UNITED STATES OF AMERICA
NUCLEAR REGULATORY COMMISSION
ATOMIC SAFETY AND LICENSING BOARD PANEL

IN THE MATTER OF:)	
)	
INTERNATIONAL URANIUM (USA))	Docket No. 40-8681-MLA-11
CORPORATION)	
)	ASLBP NO. 02-795-02-MLA
(Source Material License Amendment,)	
License No. SUA-1358))	July 29, 2002
_____)

SIERRA CLUB COMMENTS ON IUSA’S RESPONSE TO PRESIDING OFFICER’S
REQUEST FOR ADDITIONAL INFORMATION

IUC Well MW-4 Pump Test: HGC 1999 Data, Test 2 (high pumping rate)

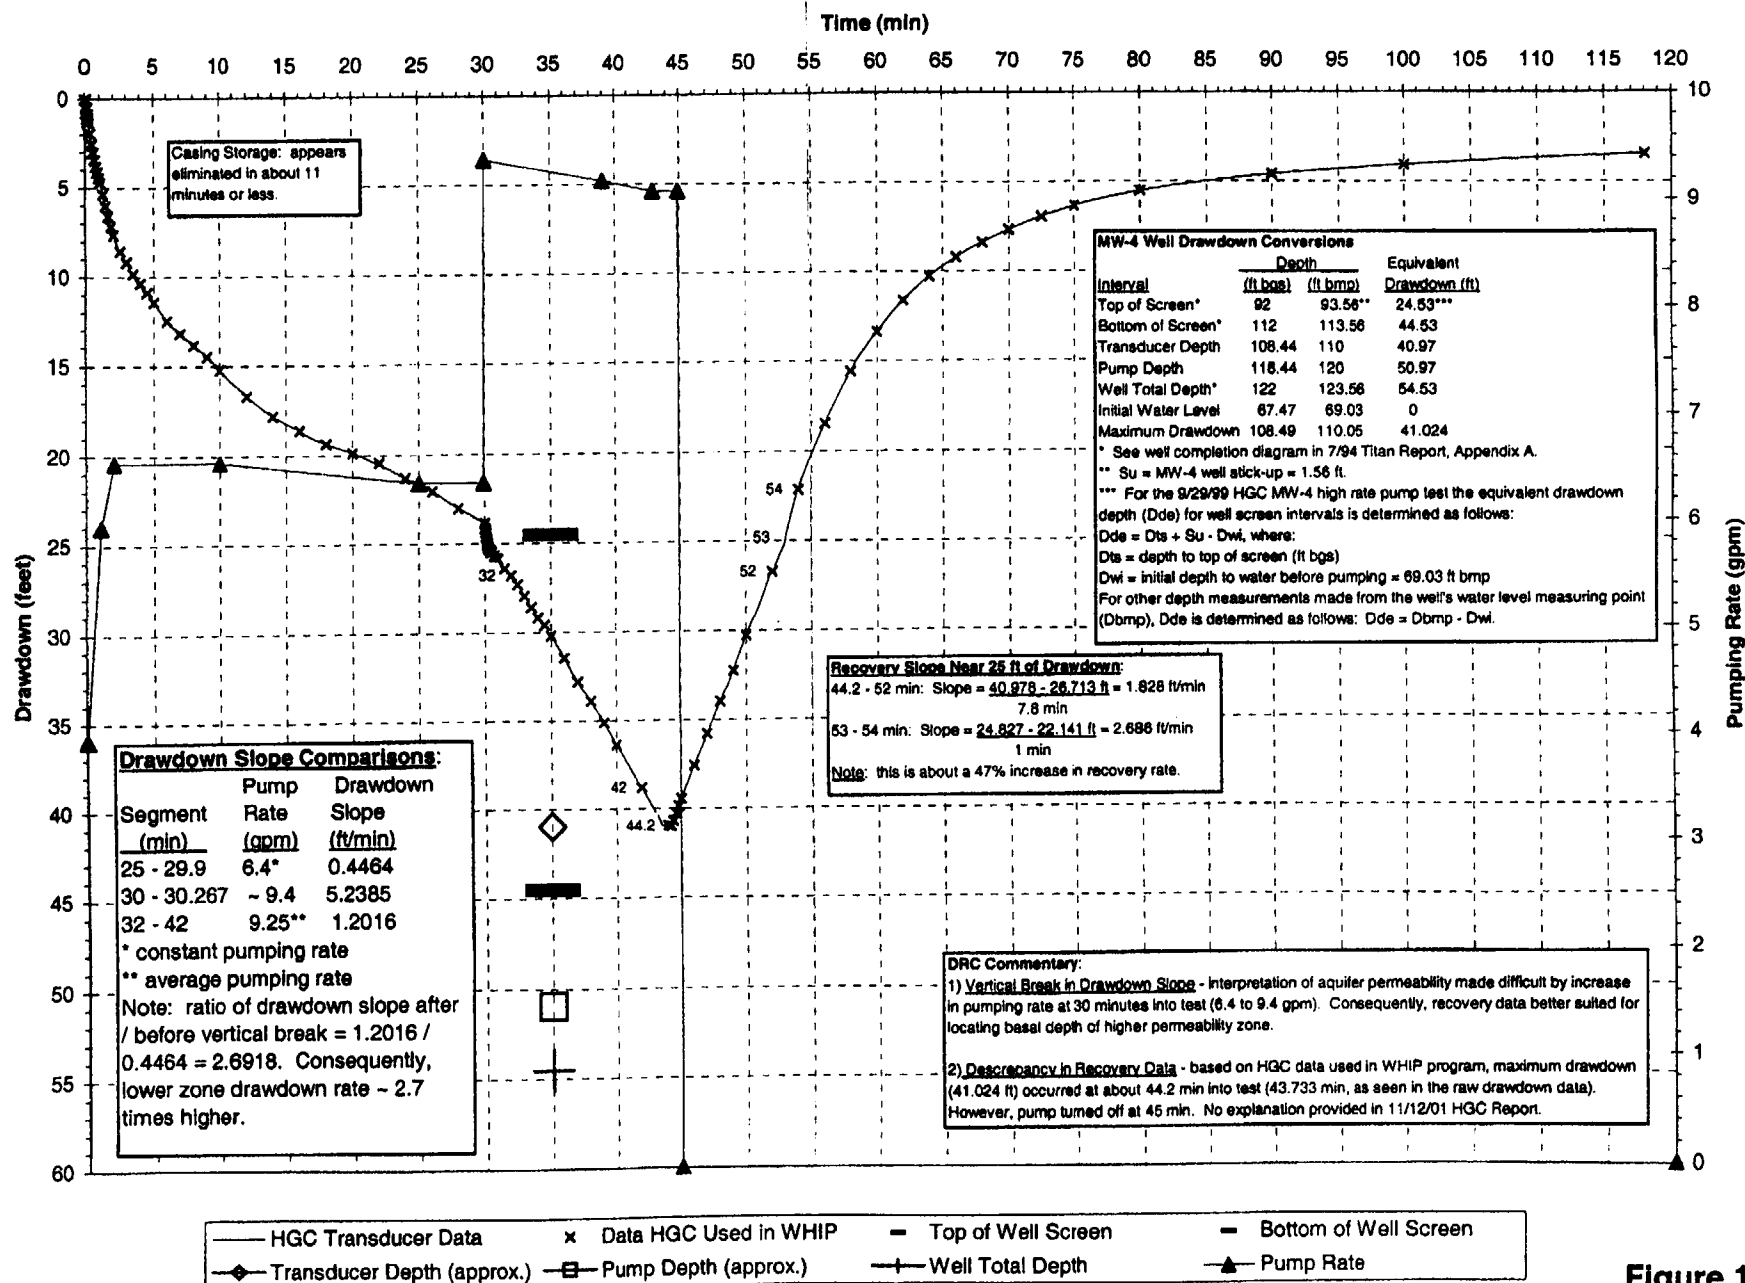
high rate test of MW-4 (see Table 1, above). Arguments could be made that IUC could have placed the pressure transducer at a greater depth to better test the location of the Jmb contact in well MW-4 (see Figure 1, below). As reported, the transducer was not set lower than 110 ft bmp at the time of the high rate pump test due to the limited length of the transducer cable (12/21/01 HGC facsimile). Despite this constraint, DRC staff have concluded that a pumping water level below the 108 ft bgs interval combined with a sustained well yield during this portion of the pump test both suggest the Jmb contact is deeper than 108 ft bgs.

- A. High Initial Water Level in Well – review shows that before pumping commenced the initial water level in the well was 24.53 feet above the screened interval (see Figure 1 below). As a result, well MW-4 was screened across only a portion of the shallow aquifer, and

- B. Apparent Lack of Unique Solution: 1999 Recovery Response High Rate Data – the water level recovery portion of the 1999 high rate test shows two different recovery slopes are apparent in the MW-4 recovery response (see Figure 1 below). The transition of these two different recovery slopes occurs at about 53 minutes into the test (which corresponds to a drawdown equivalent interval of about 25 feet). Prior to 53 minutes, well MW-4 exhibited a recovery rate of about 1.83 ft/min. After this point, the well recovered at a 47% higher rate, 2.69 ft/min. However, it is important to note that at this same 53 minute time interval, the water level in well MW-4 rose above the top of the well screen located at a depth of 92 ft bgs. Consequently, it appears that the increase in the well recovery rate above and beyond this point is the product of partial penetration effects in well MW-4.
